TOGA CENTRAL (FORMER PARCEL POST BUILDING)– SSD-33258337 - RESPONSE TO SUBMISSIONS (BUILT HERITAGE)

This letter has been prepared in response to the agency comments relevant to SSD – 33258337. This letter specifically responds to the heritage comments provided in the following:

- Advice on Environmental Impact Statement provided by the City of Sydney dated 30 September 2022 (SSD-33258337),
- Referral advice from Heritage NSW dated 16 September 2022 (DOC22/816136-3)

Figure 1 General Arrangement Lower Ground Level, Drawing no. 10GR0000

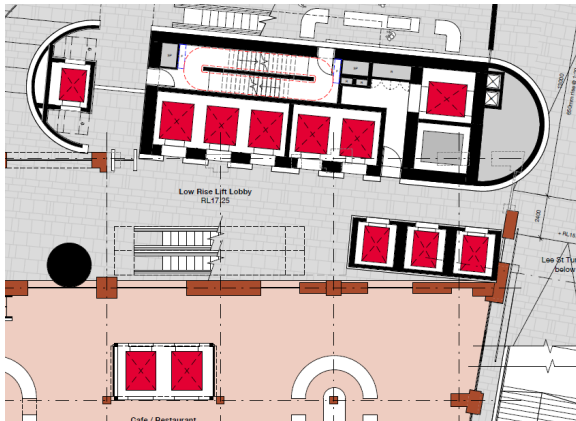
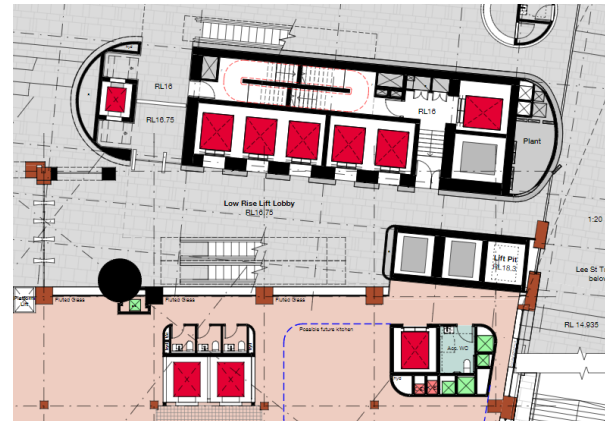
The proposal involves extensive demolition of the eastern facade beyond that which occurred in 1998-99, which will reduce it to three facades and will have an adverse impact on the heritage significance of the building and is not supported by the City. While the altered section of the eastern facade is graded as being of moderate significance in the Conservation Management Plan (CMP) prepared by Urbis, the south-eastern curved corner is of exceptional significance.

- ***The City does not support the extent of demolition to the eastern façade and recommends amending the design to allow for the retention of the south-eastern corner of the building, which is of exceptional heritage significance. This may require the eastern pod to be relocated further eastwards and be made parallel to the eastern facade.***

The eastern pod is a structural necessity for the proposed development. It has been appropriately located to the east of the former Parcel Post Building, as the façade of least significance for the reasons outlined in detail in the HIS. Even so, the heritage benefit of interpreting the building in the round despite demolition of some reconstructed and original fabric to the highly modified east façade is acknowledged. Therefore, treatment of the proposed eastern pod and eastern façade ensures a clear legibility of the northeast corner of the building through a substantial return of the east façade to the south.

To achieve the extent of the above return (and achieve the structural requirements) it is required to locate the core to the south of the eastern façade which would result in the loss of the southeast corner. Refer to the accompanying architectural response which explains the necessity of the blade wall which connects the east core, the smaller core within the floorplate of the fPPB and the Y columns above.

No part of the building is identified to be of exceptional significance in the CMP as stated in the submission, however the impact on fabric of high significance is acknowledged. Urbis considers the impact to be an acceptable outcome given the substantial retention of the northeast corner and the lack of contribution that the southeast corner makes to the visual context of the Devonshire Street Tunnel and Henry Deane Plaza.

Notwithstanding Urbis' assessment of impact, the issue raised in the Council submission is acknowledged and the treatment of the southeast corner has been revised following discussions between Bates Smart, TOGA and Urbis Heritage to treat the corner in a logical way that would lead to a more acceptable heritage outcome. It should be noted that this approach was agreed with the Design Integrity Panel at the DIP 3 Session which occurred on the 7th June 2022.

The demolition of the corner and incorporation of the return of the existing quoining and façade detail on the south façade, to the east façade, are retained in the proposed design. This would maintain the appearance of the façade as a rational, finished façade within the context of the development and would maintain the symmetry of the facade. This will create the appearance of the south-eastern corner despite its demolition, thereby contributing to a more sophisticated, interpretive understanding of the original massing and scale of the fPPB.

The DIP also supported maintenance of unrendered brickwork on the inside face of the wall to the point where it intersects the new lift core. This brickwork return would ensure that the southern façade has sufficient depth to be legible as part of the structure behind.

This change is, in Urbis' opinion, a good heritage outcome, sympathetic to the significance of the fPPB and the greater Central Railway Group.

Figure 3 General Arrangement Plan, Level 02, Drawing no. 10L02000

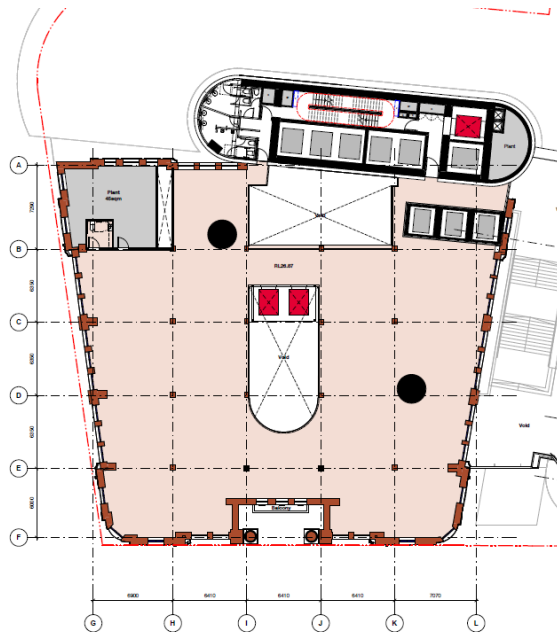
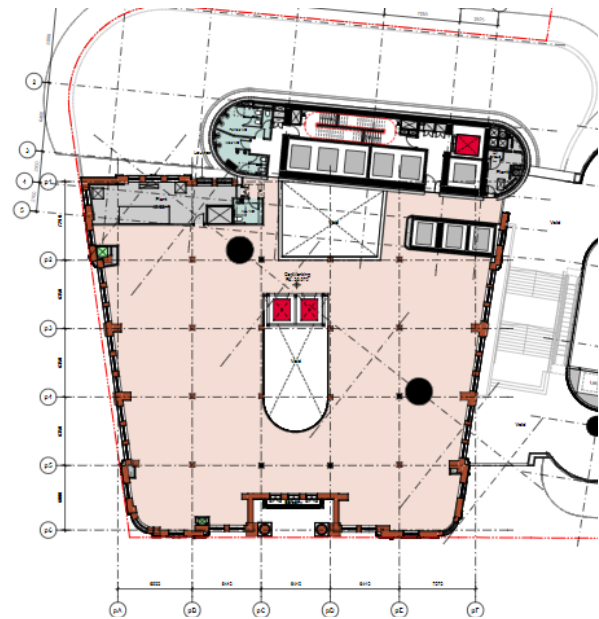
The proposed internal demolition of floor fabric for the void between Grids A-B and I-K (the eastern-most void) is not supported as it has no historical basis, removes fabric of moderate significance, removes the spatial appreciation of each floor and reduces the useable space of the building. The western-most void is supported as it is reasonably consistent with historic additions that incorporated a central light well.

The demolition of fabric for the internal voids creates potential risk for damage to significant detailing of the stucco of the columns because of the proximity of the edge of the columns to the zone of demolition. A heritage asset construction methodology should be provided to outline mitigation measures to limit potential risks to internal columns and finishes.

- *The internal demolition of floor fabric for the void located between Grids A-B and I-K is not supported by the City.*
- *A heritage asset construction methodology should be provided to establish mitigation measures to limit any risks to the internal columns and finishes and to avoid adverse impacts. The Heritage Impact Statement should also address this risk.*

The purpose of the void space is to allow for additional natural lighting throughout the building. This will increase the amenity across a deep floorplate. Therefore a void has been retained between grid sections A-B and I-K, however the width of the void between Grids I-K has been reduced to minimise demolition of moderately significant fabric. The modified void would not occupy entire spaces between the structural grid and the void would therefore be discernible as a later insertion.

The retention of a void in this location is acceptable from a heritage perspective as the only elements of significance in the fPPB constitutes the internal grid and associated structural columns. The internal structure and fitout have historically been utilitarian and generic by design in order to better accommodate different uses. The remnant internal fabric, while significant as part of the structure, is therefore of no significant detail. It is structural by nature, and its removal in sections will not change

the character of the internal spaces or have an adverse heritage impact. The legibility of the internal spatial layout, particularly between floor levels, will be retained despite the inclusion of the void space.

Figure 2: Ground floor plan (left) and Levels above ground level (right) with area of concern outlined in green

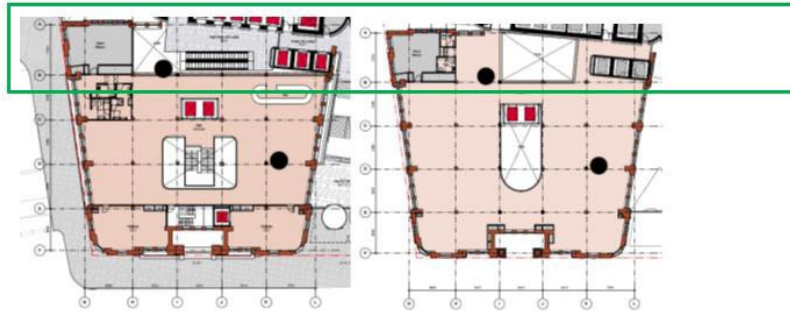
Of particular concern is the quantum of insertions proposed within the building between Grids A and B (see Figure 2 below), which reduces the floor plates to a fragmented series of passageways. The plant room, column, void and lift core result in almost total demolition of the floor plates in this area

In particular, the proposed escalators are not supported as they alter the historic character of the building. Additionally, the demolition of fabric raises concerns of the potential risk of damage to significant internal detailing of the stucco of the internal columns.

Figure 7 General Arrangement Ground Level, Drawing no. 10GR1000

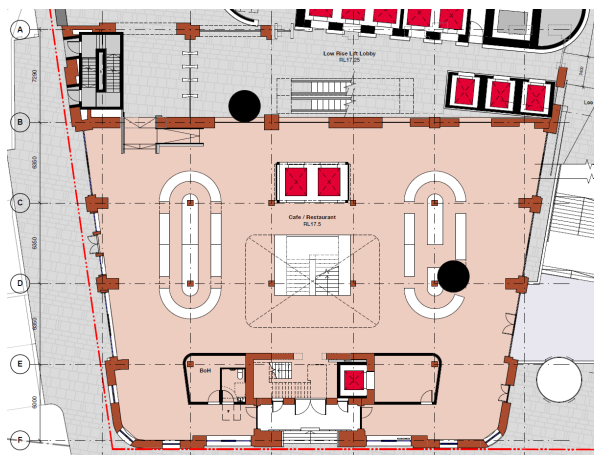
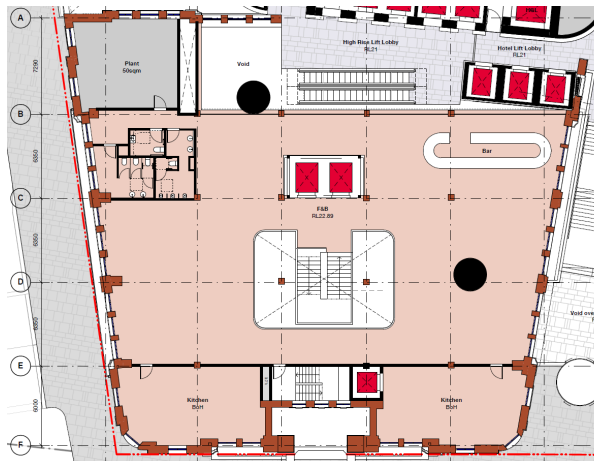
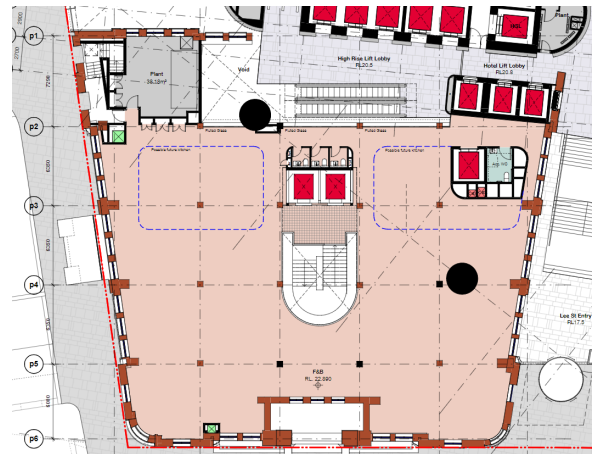
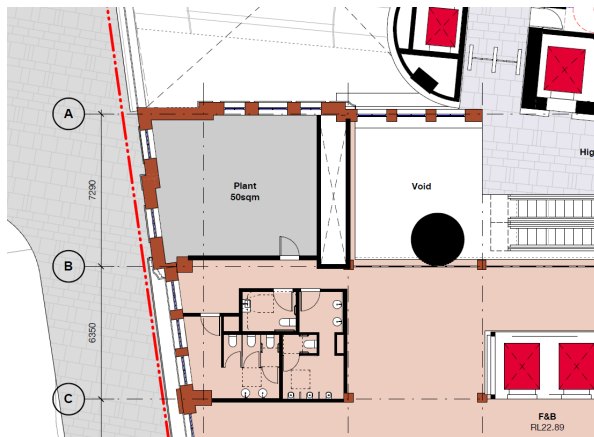
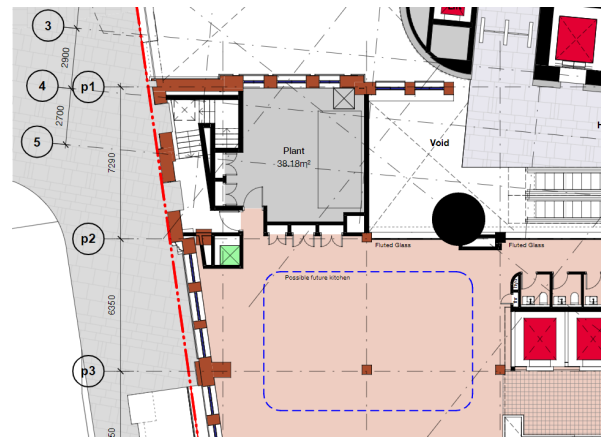
It is acknowledged that the proposed location of the two structural columns within the fPPB has been carefully considered and their introduction will not interrupt the presence of original structural components. However, the quantum of all proposed insertions and voids into the fPPB (in addition to the two columns) results in excessive demolition and fragmentation of the interior spaces and erodes the internal spatial configuration and historic character. The quantum is such that the proposal is inconsistent with CMP Policy 61.

The amount of internal demolition and subsequent fragmentation of each level of the former Parcel Post building should be reduced. To conserve the character and spatial integrity of each floor level, it is recommended that:

- *Consideration should be given to whether the proposed escalators and the lift core comprising three lifts servicing up to Level 19 between Grids K and L would be better relocated into the southern pod from a heritage perspective.*
- *The extent of insertions between Grids A and B should be minimised.*
- *A specific heritage asset construction methodology should be required to review the current proposed construction methodologies and to detail mitigation measures to limit potential risks to the internal columns and finishes.*

The proposed design has been revised to minimise the extent of the internal insertions and voids within the fPPB. It is acknowledged that the same quantum of insertions is proposed however, this revision minimises the scale of the insertions in line with CMP Policy 61.

The proposed relocation of the escalators and lift core between grid section K-L has been investigated however has been discounted from the revised design due to structural and operational feasibility. The presence of escalators and lift cores has been situated in this space as the most practical and logical option, to provide necessary structural stability with as little intervention into heritage fabric as possible. The core occupies an area to a corner of the building and it is not prominent within the floorplate. However, other modifications to the design as noted above will mitigate the impact of locating the escalators and lifts in this space.

The central atrium and stairwell will be reduced at lower ground and ground floor level to be in keeping with the levels above. In its prior design the atrium included a larger void over C-E and H-K from the lower ground level and up, with the overall central stairwell reducing in size to the upper levels. The modifications to this design will reduce the expanse of the stairwell and void above to within the C-E and I-J only. This change will subsequently result in the reduction of internal intervention into existing fabric.

To further reduce the amount of demolition and disruption to interiors, the plant rooms previously proposed to be located adjacent to the interior of the eastern elevation have been setback further away to the west. The legibility of the interior of the north east corner will therefore be somewhat enhanced.

As discussed with regards to the above recommendation, modifications to the design have considered the scale of intervention to fabric between grid section A-B. The scale of internal demolition and intervention in this area has also been reduced overall as seen in the modification to the void space, the plant room and further consideration to the location of the escalators and lift core. In short, the overall amount of internal demolition required has been reduced where possible and will result in a more acceptable use of the space from a heritage perspective.

A significantly less intensive program will be inserted to the interior area adjacent to the western façade at ground floor. The previously proposed kitchens, stairs and lift have been relocated to better enable retention of the original spatial arrangement at ground floor.

Figure 11 General Arrangement Ground Level, Drawing no. 10GR1000

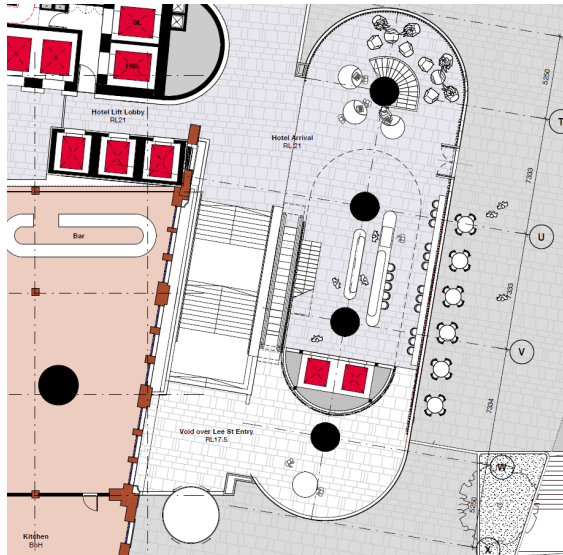
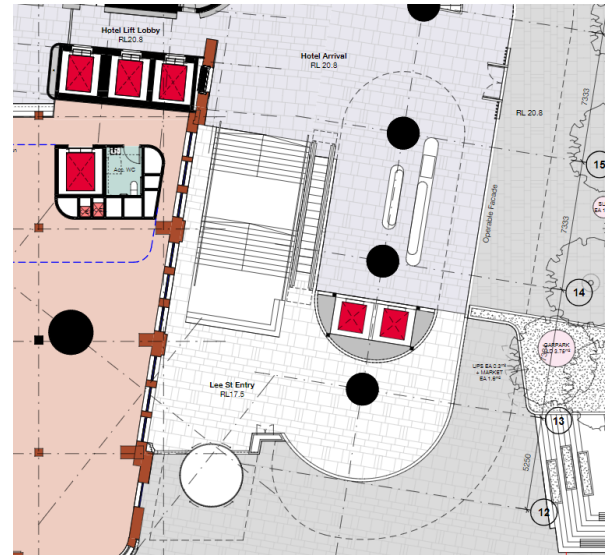
The proposed atrium connecting the southern pod to the fPPB will have a negative impact on the visual appreciation of the building.

The proposed raised levels of the southern pod that align with the Henry Deane Plaza result in two of the three original significant shopfront openings of the ground floor (between Grids B and D) being visually covered by the stair down to the Lee Street level. A narrow void is provided between the stair and the two shopfronts. This inadequate visual curtilage has negative impacts on the appreciation and setting of the fPPB.

- *The stair within the atrium adjacent to the southern pod should be offset from the southern facade of the fPPB by a considerable distance to allow for greater visual curtilage around the two former bronze framed shopfronts maintaining visibility to them and their ability to function.*

- *The plaza levels could be modified to be lower to reduce the overall length of the stair. The extent of the proposed atrium westwards along the southern facade could then be reduced.*

The stair within the atrium adjacent to the southern pod has been further offset from the southern facade of the fPPB. It would be 900mm offset from the façade and the head height constraints in the tunnel below would be limited. The stair would therefore be entirely separate to the southern façade.

The floor level for the hotel arrival space has been reduced in height from RL 21 to RL 20.8 to further reduce the overall length and height of the stairwell in order to minimise this visual impact.
